# FNSB ADMINISTRATIVE HEARING

AGENDA  
10:30 a.m.  
February 1, 2018

Daniel Welch,  
Platting Officer**SD019-18 Raven Tree Subdivision**

Daniel Welch,  
Platting Officer**RP017-18 (Cache Creek Subdivision)**

**PRELIMINARY PLAT**

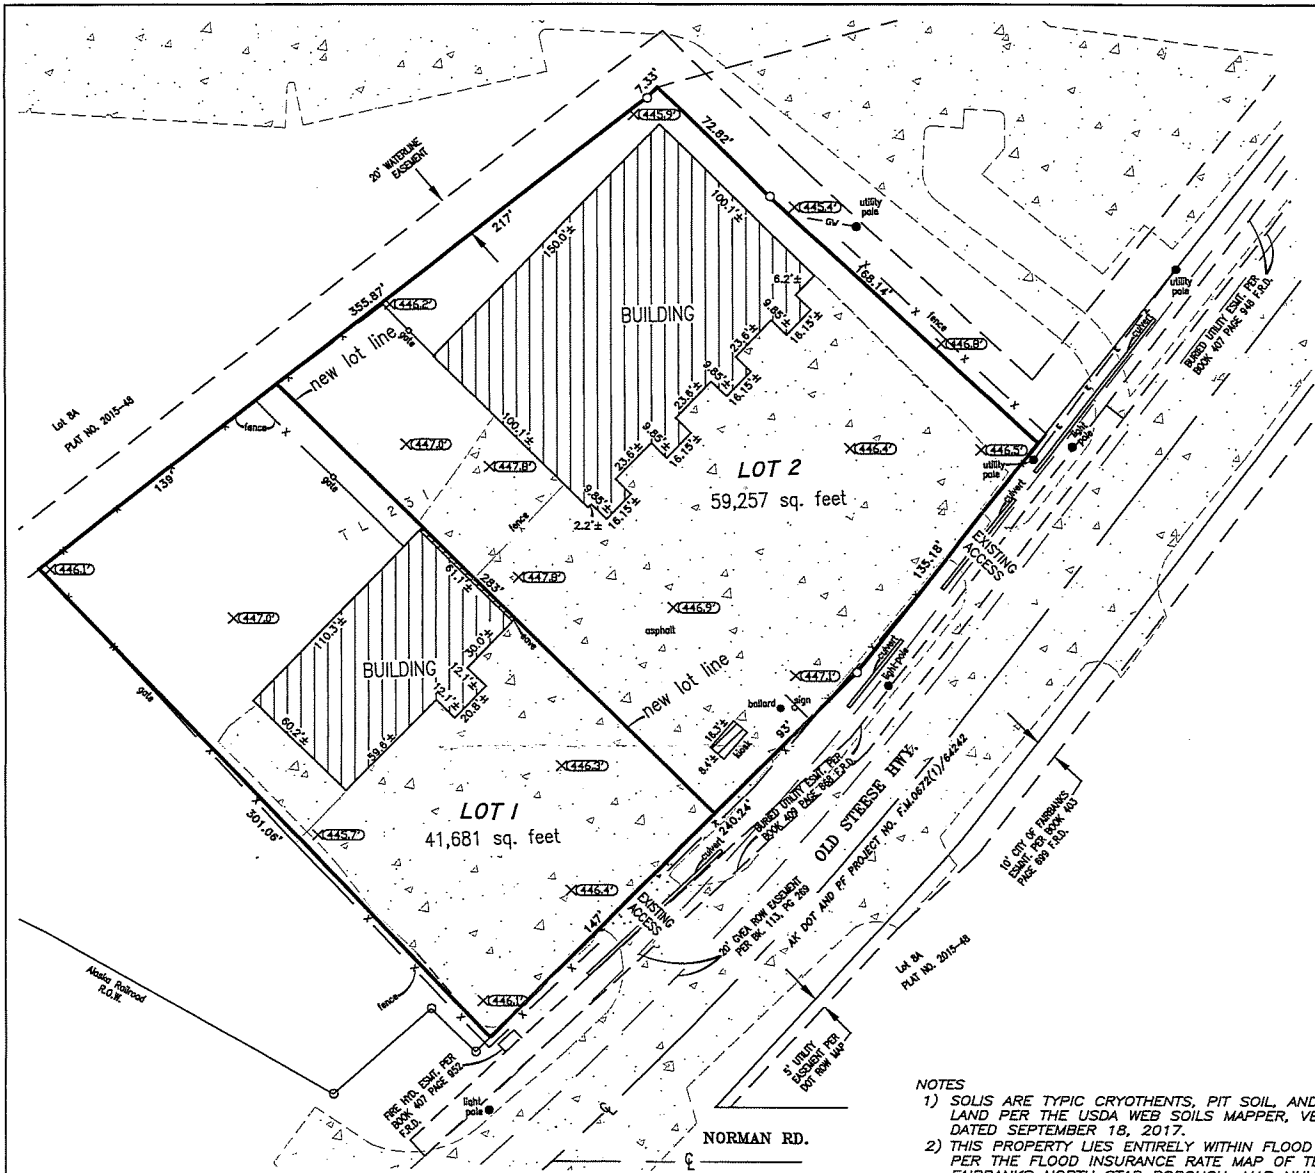
1. “There are several typos and notes that probably don’t need to be on the final plat.
2. No other comments.”

Notes 3, 4 and 5 shall be removed from the plat because the property is served by municipal sewer and water.

Note 8 will be removed from the plat because two additional notes will describe any access restrictions formed by the analysis of the managing authorities and FNSB Staff as described in access section above.

1. GVEA, GHU and the City of Fairbanks shall be given no more than 30 calendar days to review and comment on the final plat.
2. A note shall be added to the plat that states “Modification of an existing driveway within the Old Steese Highway right-of-way will require an approved permit from ADOT&PF.”
3. A note shall be added to the plat that states “Additional direct lot access from Lot 1 or Lot 2 onto the Old Steese Highway is prohibited.”
4. Notes 3, 4, 5 and 8 shall be removed from the final plat.

**PRELIMINARY PLAT**  
**TRACT 11 REPLAT**  
**CACHE CREEK SUBDIVISION**  
PLAT NO. 2002-41 F.R.D.

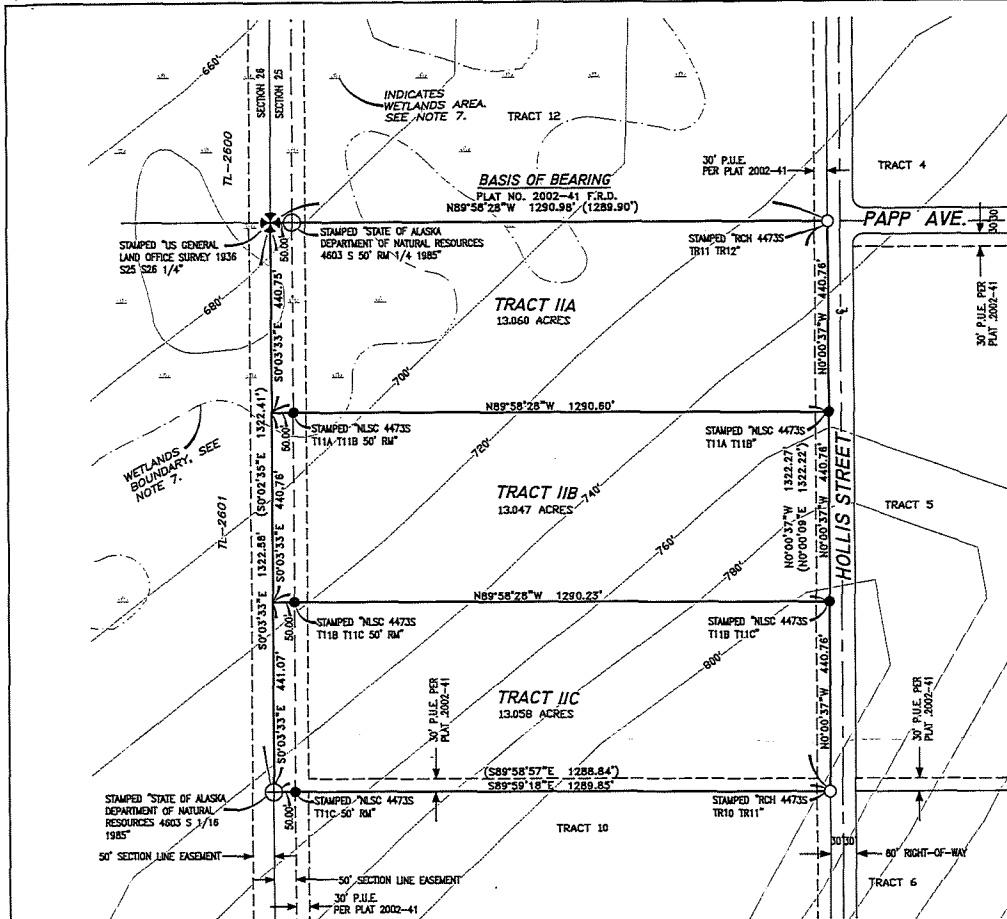
- 1) Title 17.56.020(G) eliminates the requirement to have constructed roadway access to the boundary for subdivisions of 5 or fewer lots. Thus, a constructed roadway to the boundary is not required, however these lots will not be allowed to subdivide until such a time as constructed access is in place.
- 2) Include subdivision note on plat stating above statement.”

The property contains wetlands as shown on the preliminary plat. Note # 7 and 8 shall be replaced with a single note that states “Portions of this subdivision may contain wetlands. If development plans entail the discharge or placement of dredged and/or fill material into these wetlands, issuance of an individual Department of the Army permit may be required pursuant to section 404 of the Clean Water Act prior to initiating work.”

Contours are rarely required on the final plat and are primarily used for analysis purposes by FNSB Staff. Because the contours will not be required on the final plat, Note # 5, which reference the contours on the preliminary plat, shall be removed from the plat.

1. ACS and IGU shall have no more than 10 calendar days to review and comment on the final plat.
2. A note shall be added to the final plat which states "Tracts 11A, 11B and 11C may not be further subdivided until such time as legal and constructed road access, meeting FNSB Title 17 standards, is available to the boundary of the lot proposed to be resubdivided."
3. Note 7 and 8 shall be replaced by a single note that states "Portions of this subdivision may contain wetlands. If development plans entail the discharge or placement of dredged and/or fill material into these wetlands, issuance of an individual Department of the Army permit may be required pursuant to section 404 of the Clean Water Act prior to initiating work."
4. Note 5 shall be removed from the final plat.
